RE: Preliminary Adequacy Response; M-2004-044

This letter serves as the Preliminary Adequacy Response for the 112c Construction Materials Amendment Application (AM-2), Permit No. M-2004-044. The Preliminary Adequacy Review was summarized in your letter of November 17, 2021. The italicized items are the current comment and the bold text are the responses:

TUCSON SOUTH RESOURCE
PRE-MINING AND MINING PLAN MAPS

EXHIBIT C MINING
PLAN DETAILS

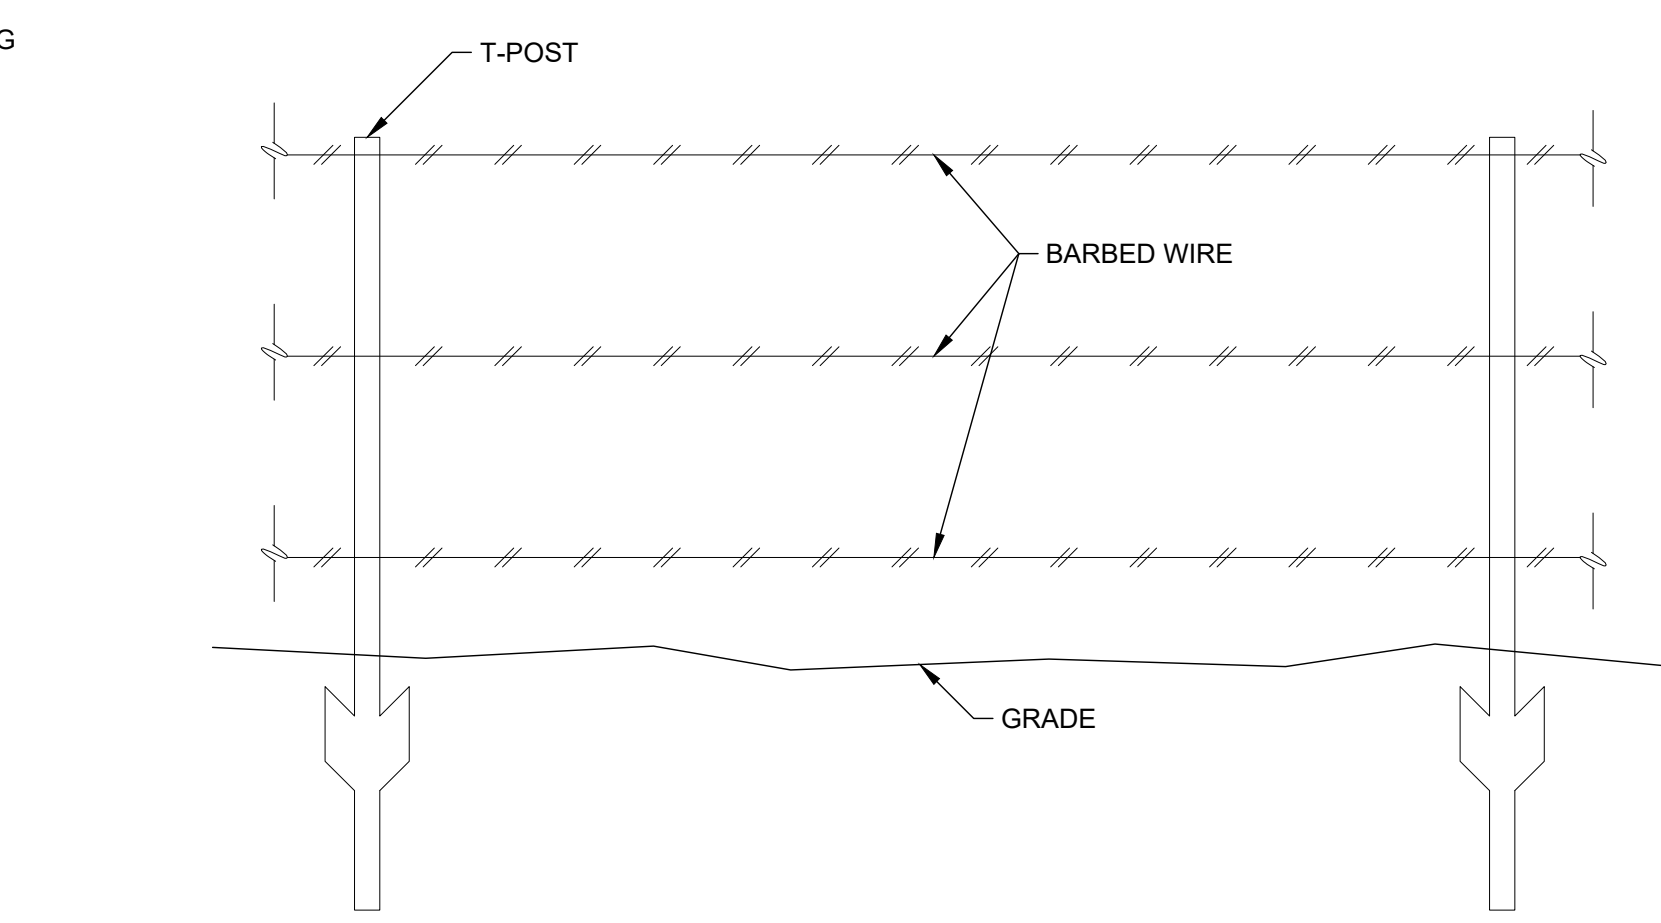
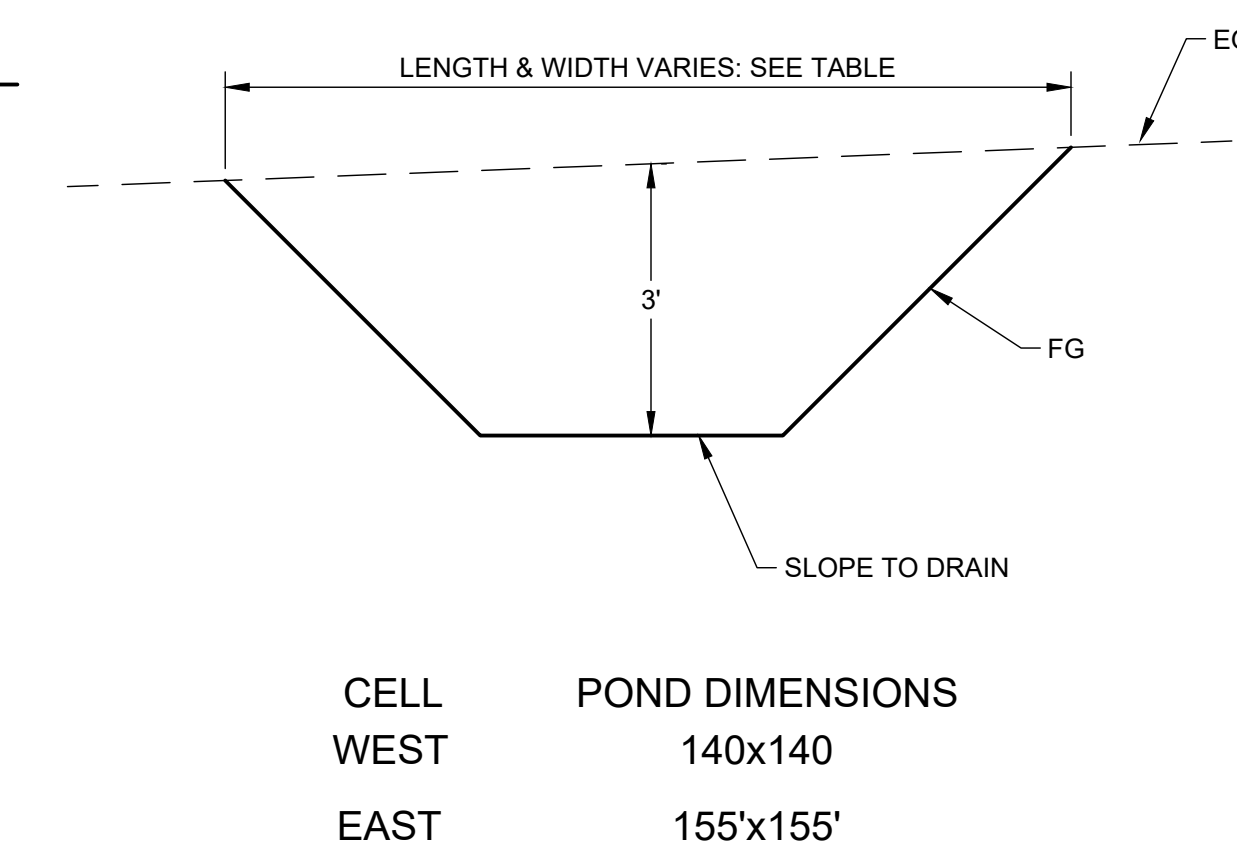
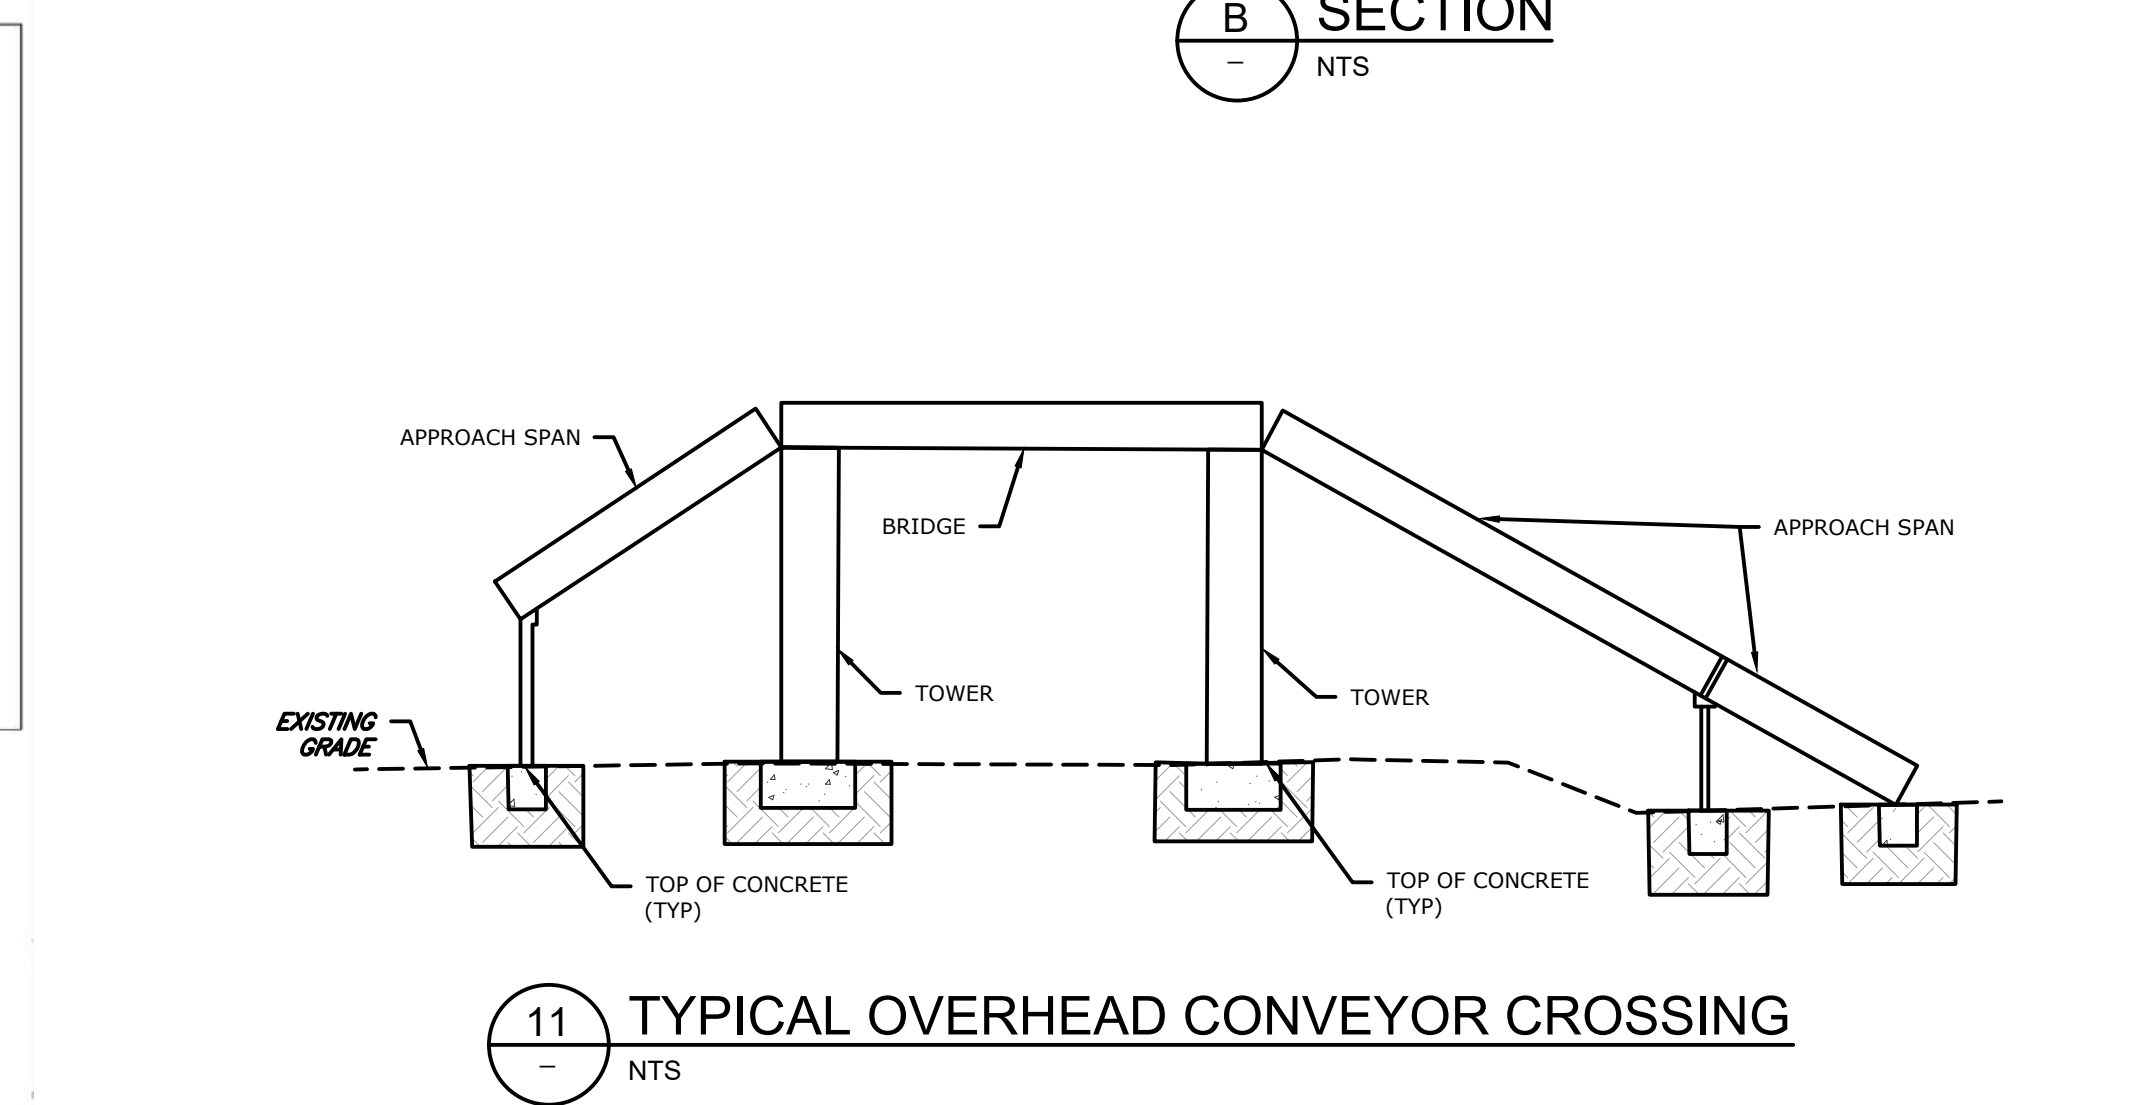
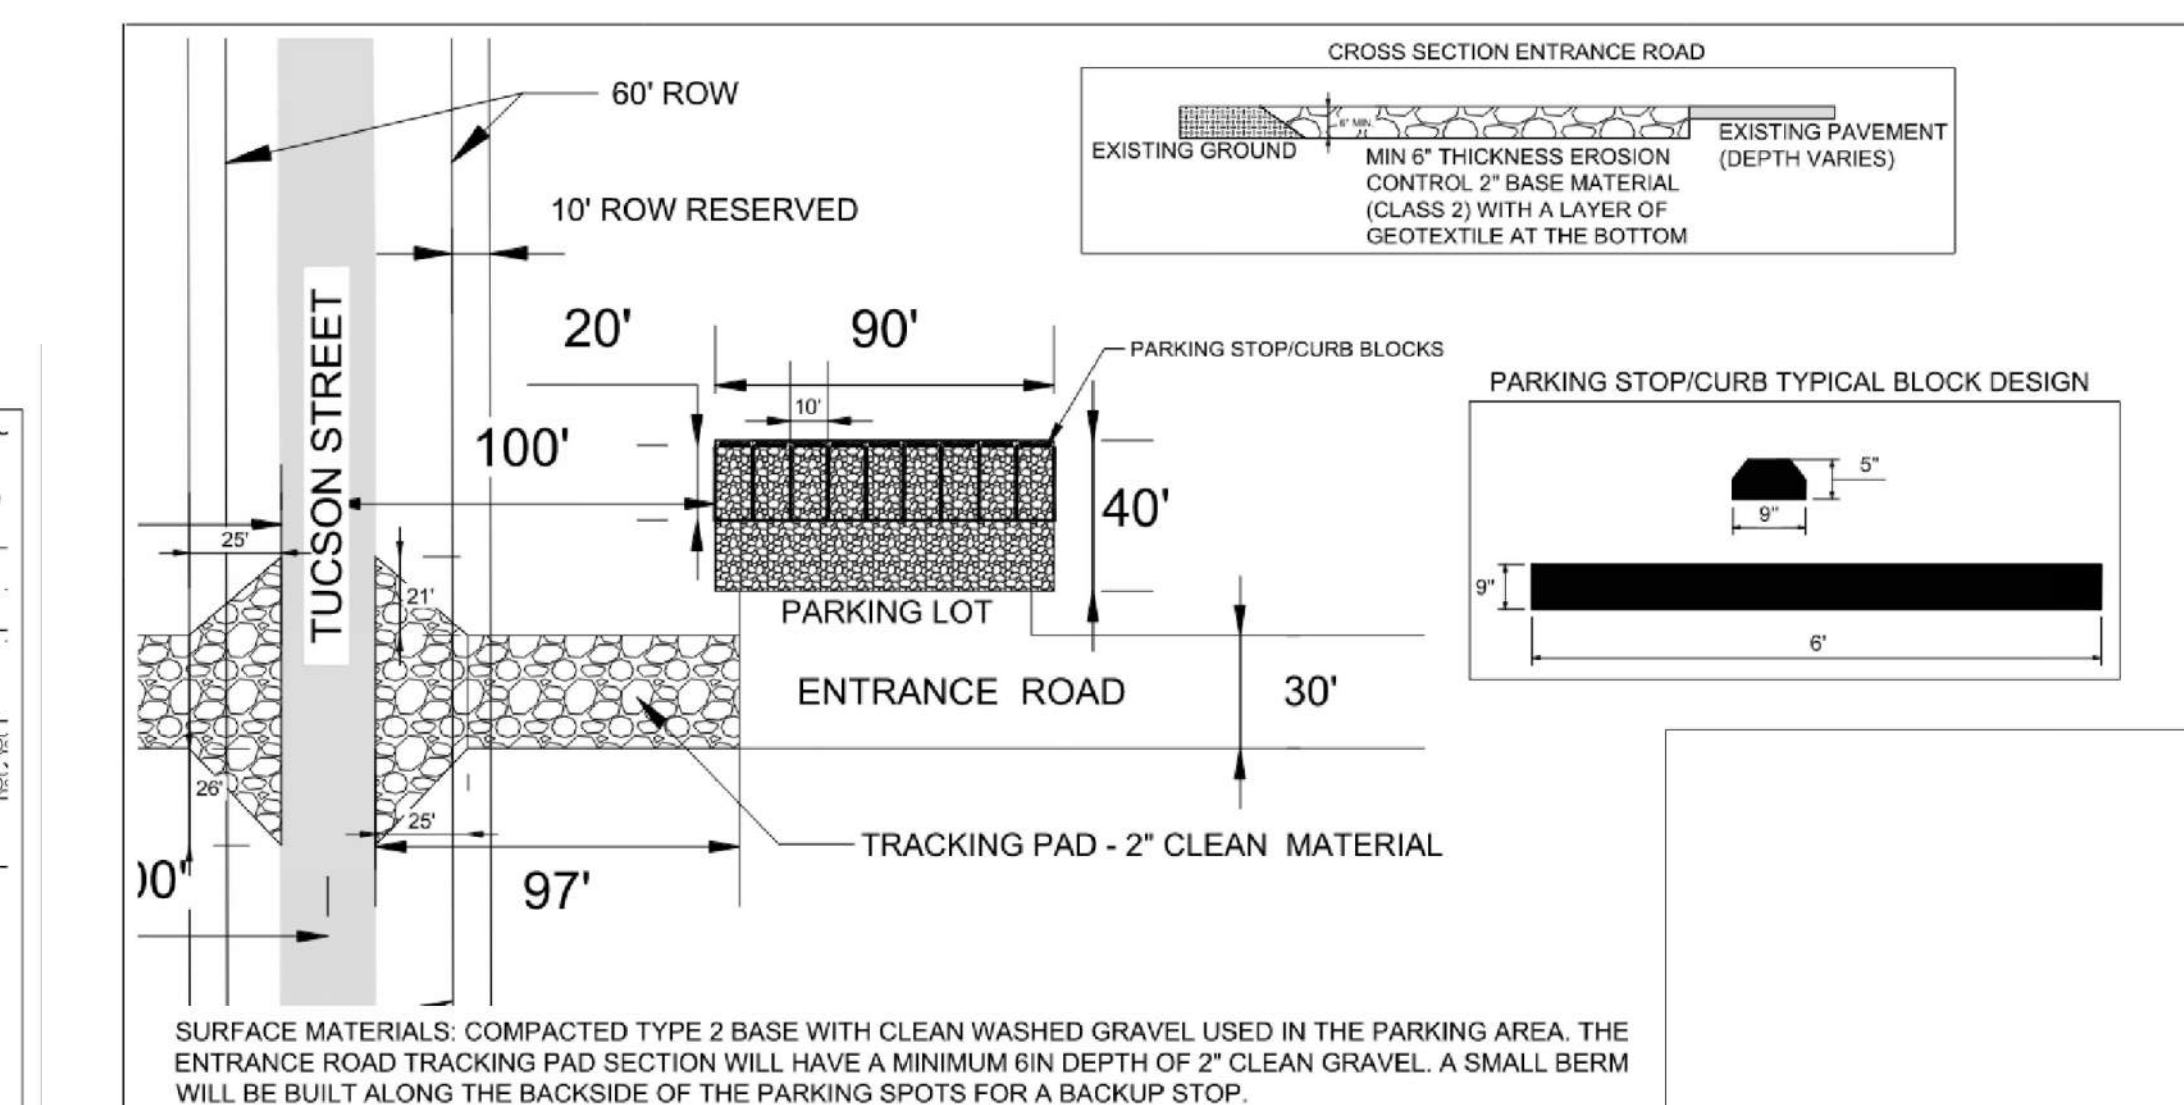
- 14.** *Please provide a typical cross section for the overhead conveyor crossing and include on map C-8.*

The typical cross section has been added to Sheet C-8. Please see the attached Exhibit C.
